UNITED STATES PATENT AND TRADEMARK OFFICE

Office Action Summary	Application No. 10/673,485	Applicant(s) LEE, JEONG-HEE	
	Examiner Quang T Van	Art Unit 3742

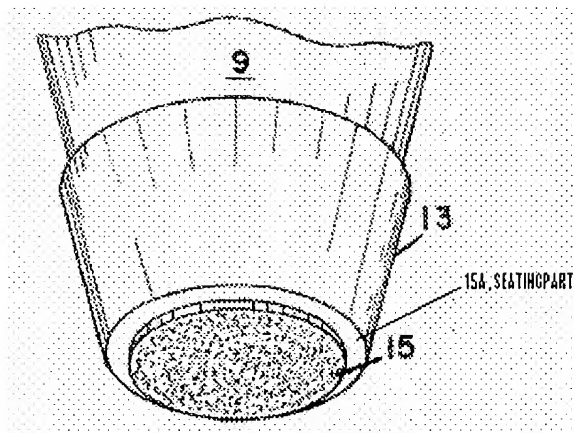
4. Claims 1 and 2 are rejected under 35 U.S.C. 102(b) as being anticipated by Uchanski et al (US 3,847,324). Uchanski discloses a non-tipping, disposable dishware having a saucer (13) comprising a cup seating part (15A, figure below) having a disc shape; and an engaging part (15) to removably engaging with a saucer holder (16) provided on the microwave oven.
